ORIGINATION FORM

Proposed Revisions to a Standard Plans Index
(Please provide all information — Incomplete forms will be returned)

Index Number: 102-602
Sheet Number (s): 1 and 2 of 2
Index Title: Two-Lane and Multilane, Work on Shoulder

SHEET
1 of 2

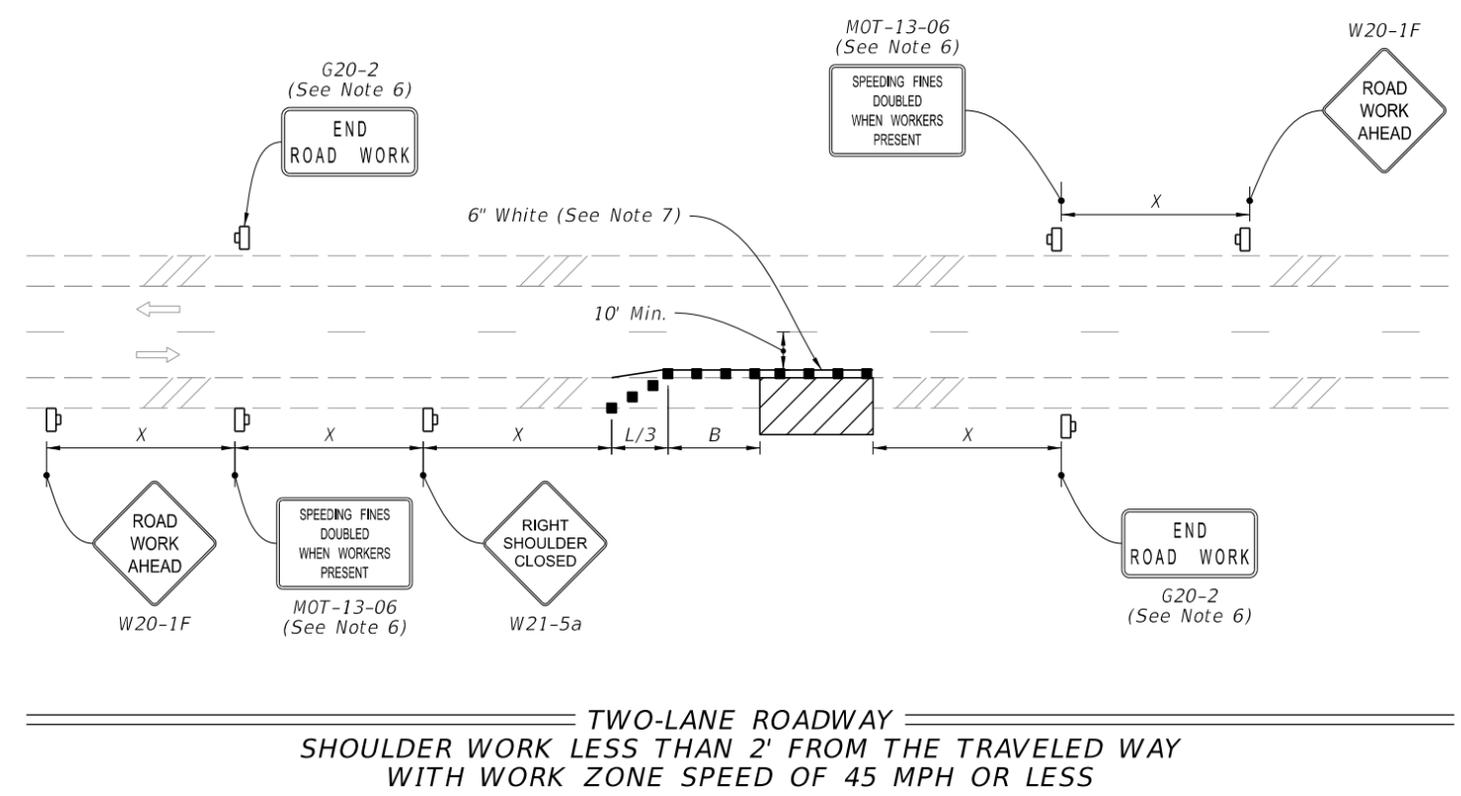
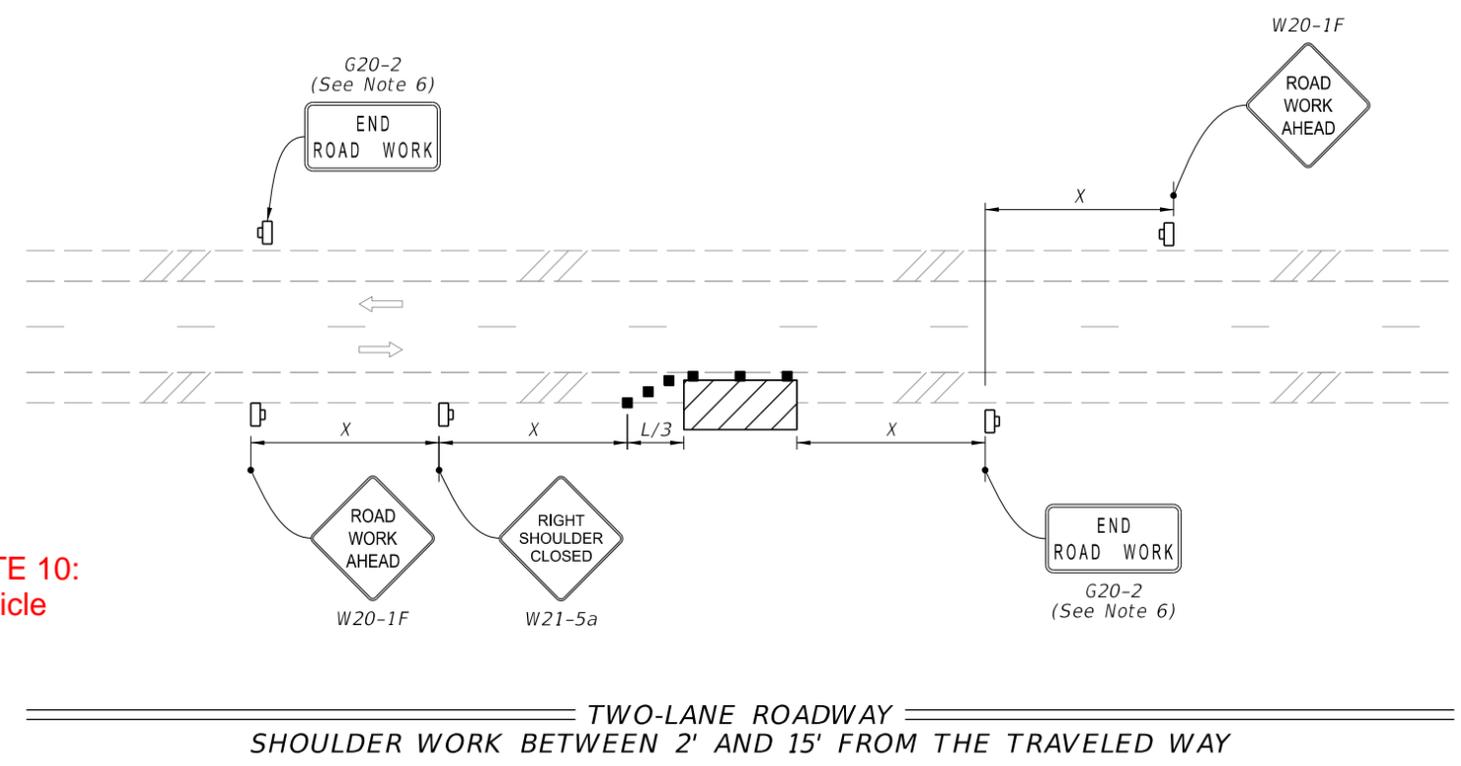
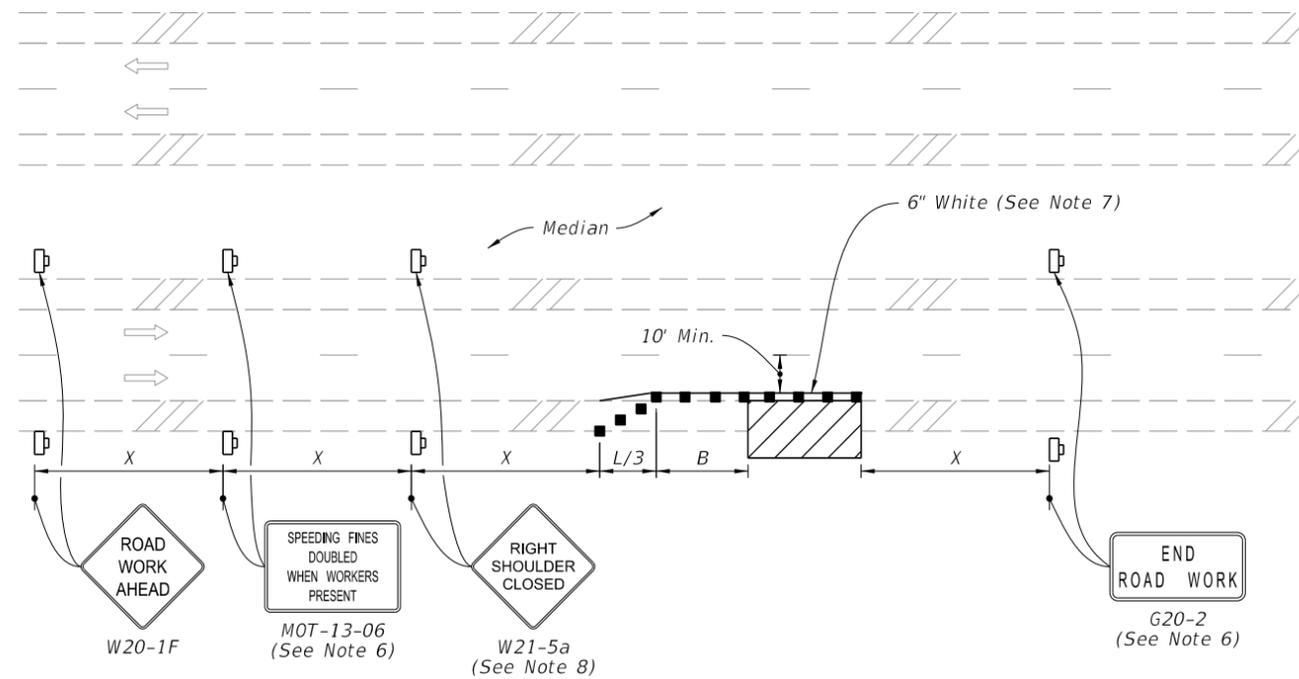
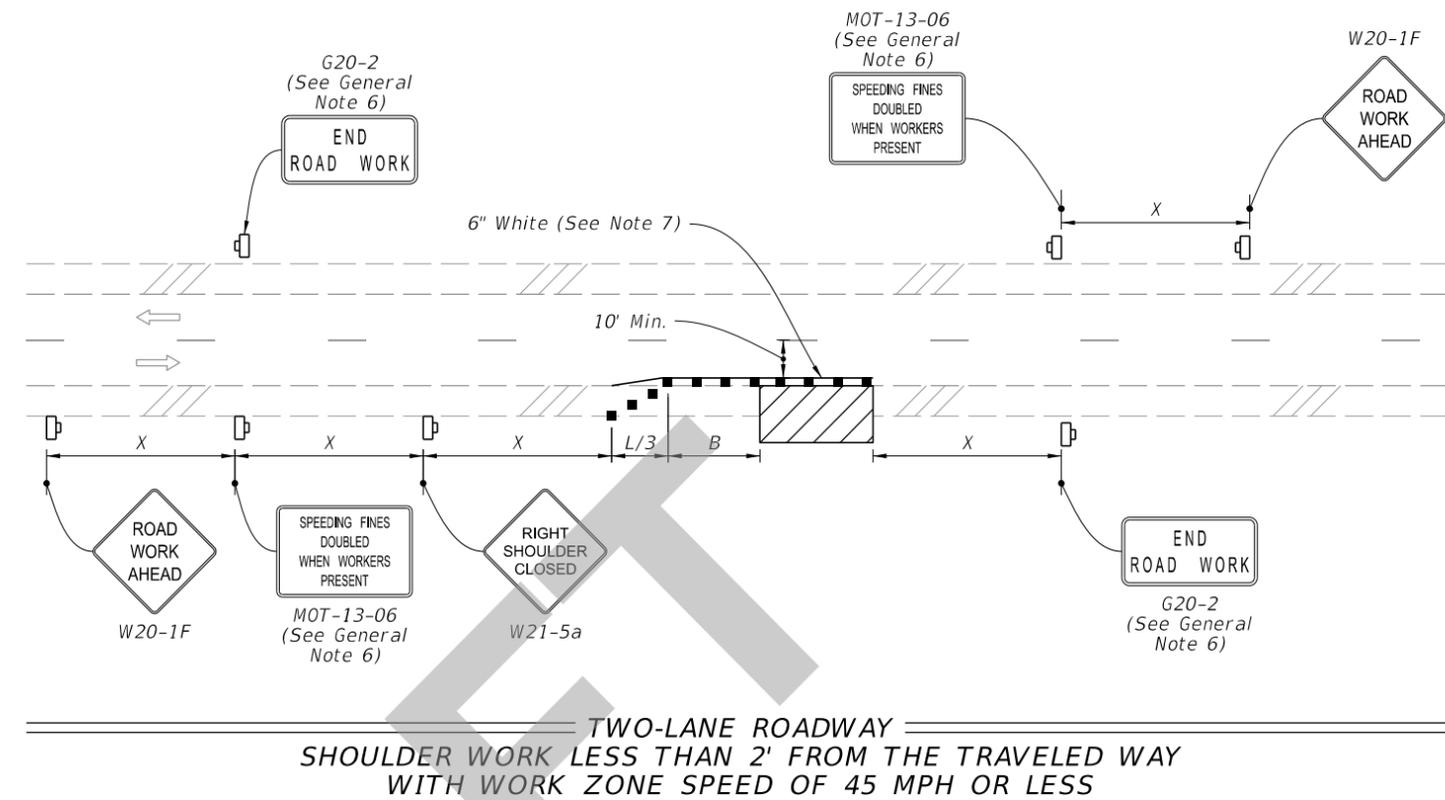
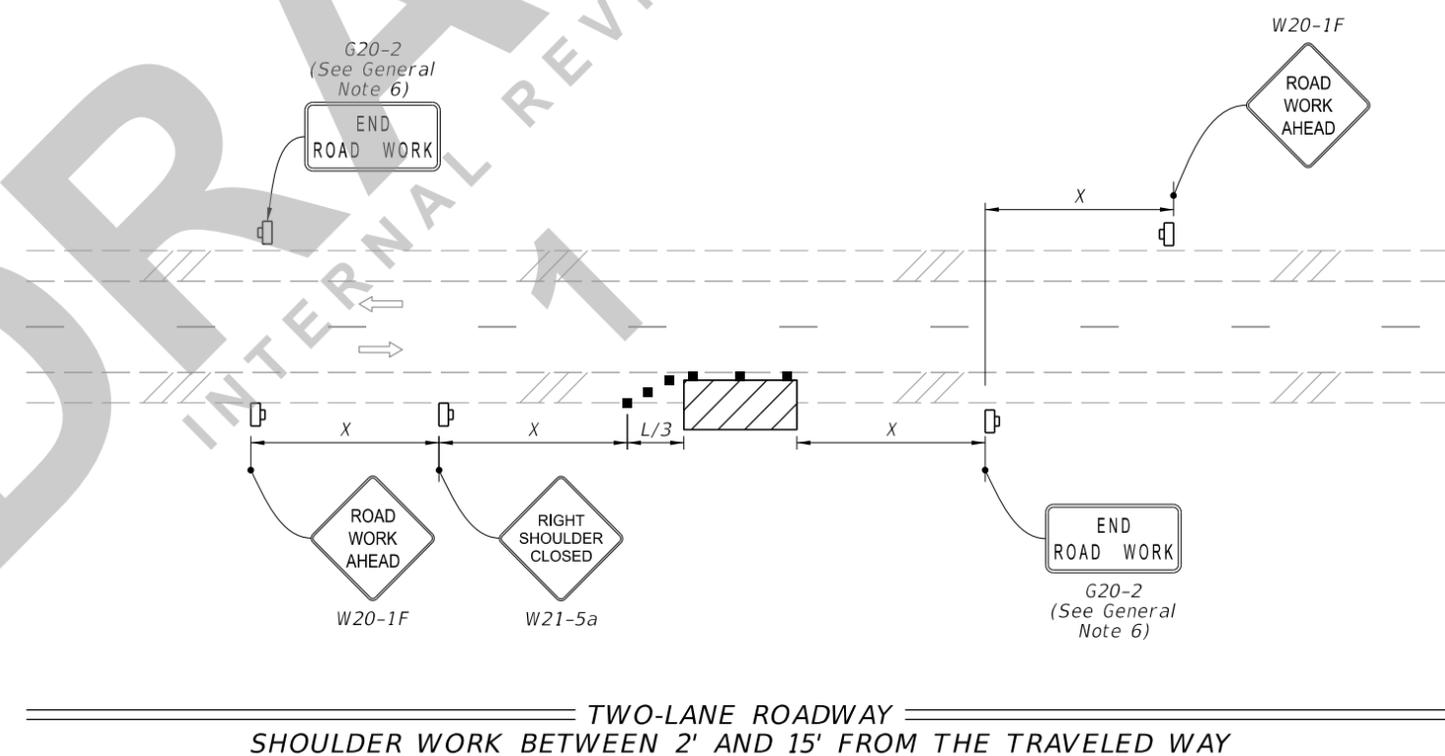
Sheet 1: Changed "Notes" To "General Notes"; Added General Note 10 "Shadow Vehicle required..."

ADDED NOTE 10:
Shadow Vehicle required...

9. When there is no paved shoulder, the "Worker" sign (W21-1) may be used instead of the "Shoulder Closed" sign (W21-5a).
10. A shadow vehicle is required for multilane roadways with a work zone speed greater than 45 MPH. The Engineer may omit the shadow vehicle where it is not feasible.

MULTILANE ROADWAY
 SHOULDER WORK BETWEEN 2' AND 15' FROM THE TRAVELED WAY

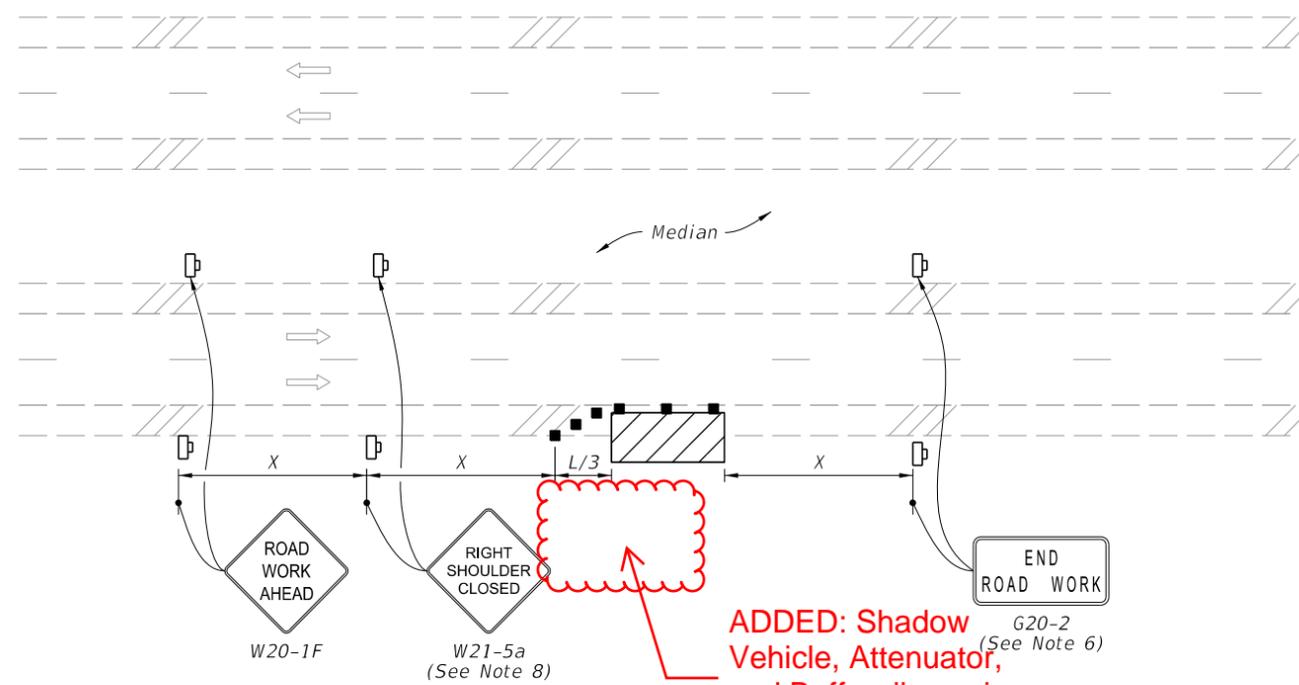
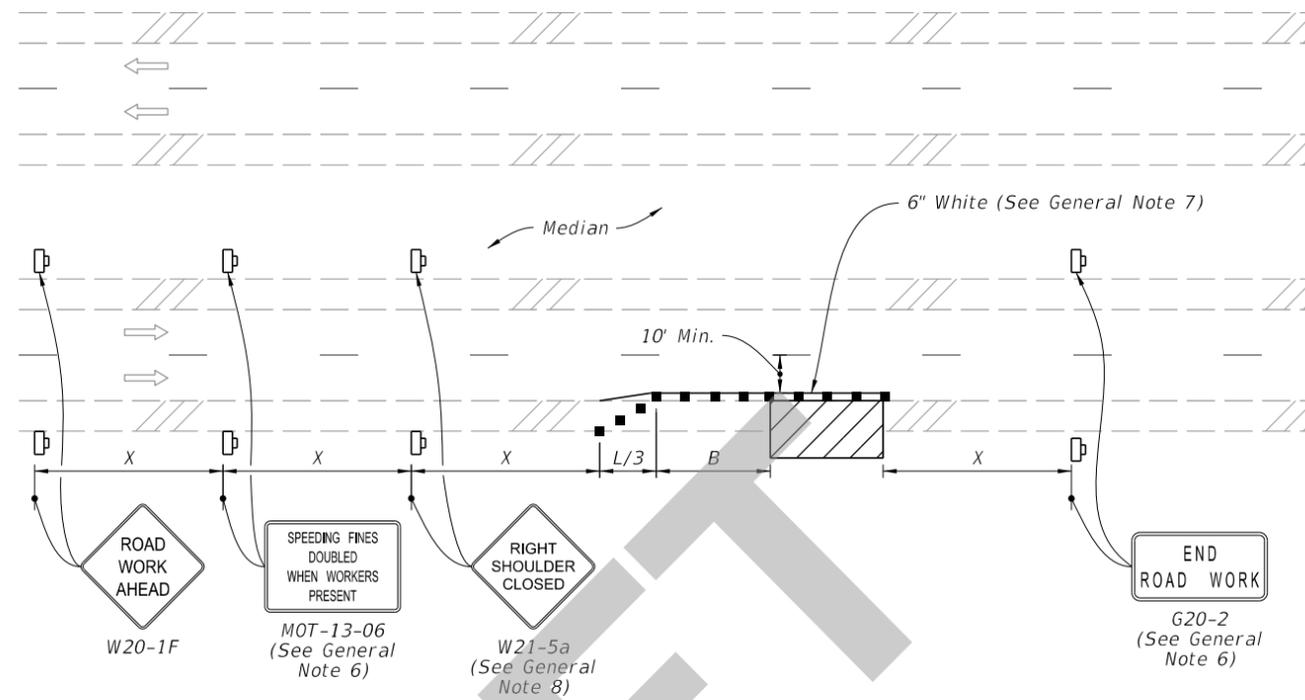
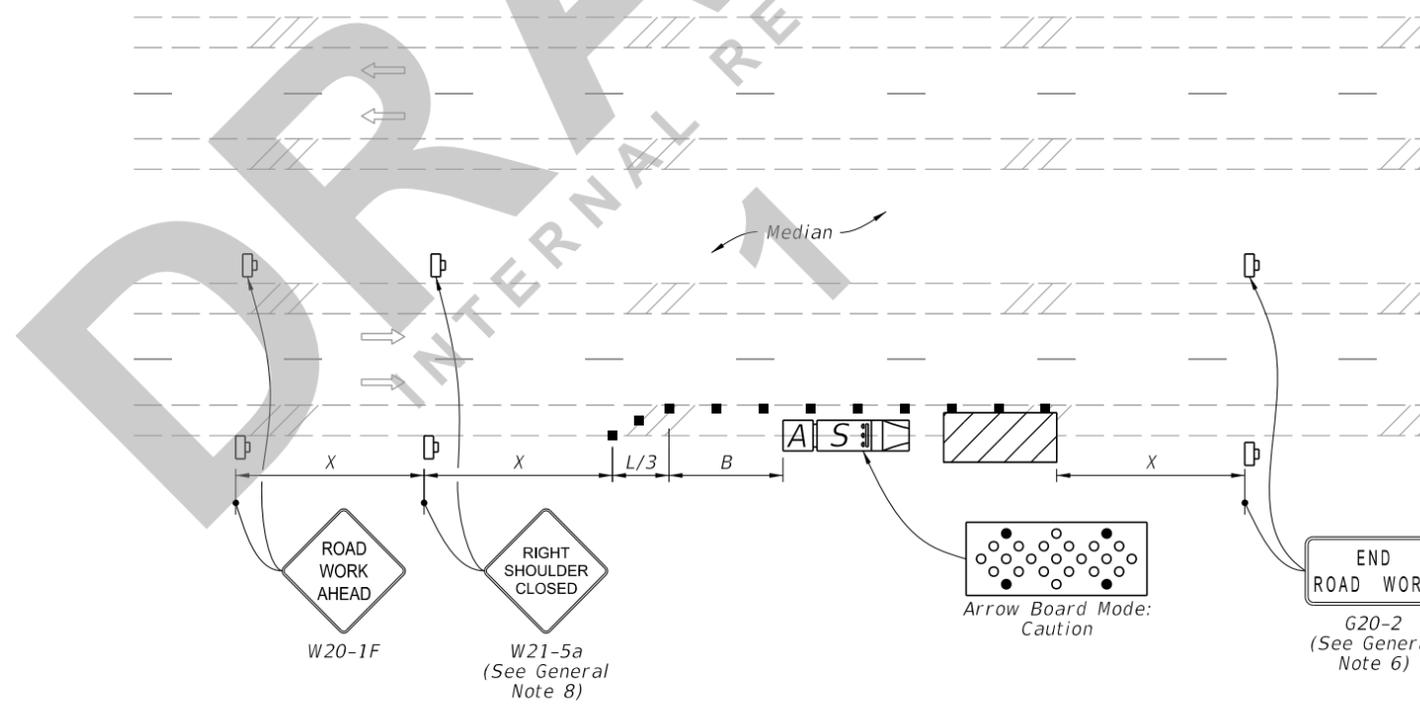
Sheet 2: Added Shadow Vehicle, Attenuator and Buffer dimension to the MULTILANE ROADWAY -SHOULDER WORK BETWEEN 2' AND 15' FROM THE TRAVELED WAY detail; Added the Shadow Vehicle and Attenuator to the Symbols

Shadow vehicles were added to the high-speed details for TMAs to be included in the TTCP. A new note was added for the Engineer to omit the TMA if it is not feasible to have one in the site specific work zone.

ADDED: Shadow Vehicle and Attenuator

-  Work Area
-  Channelizing Device (See Index 102-600)
-  Work Zone Sign
-  Lane Identification and Direction of Traffic
-  Truck/Trailer Mounted Attenuator (TMA)
-  Shadow (S) Vehicle With Warning Lights And Arrow Board
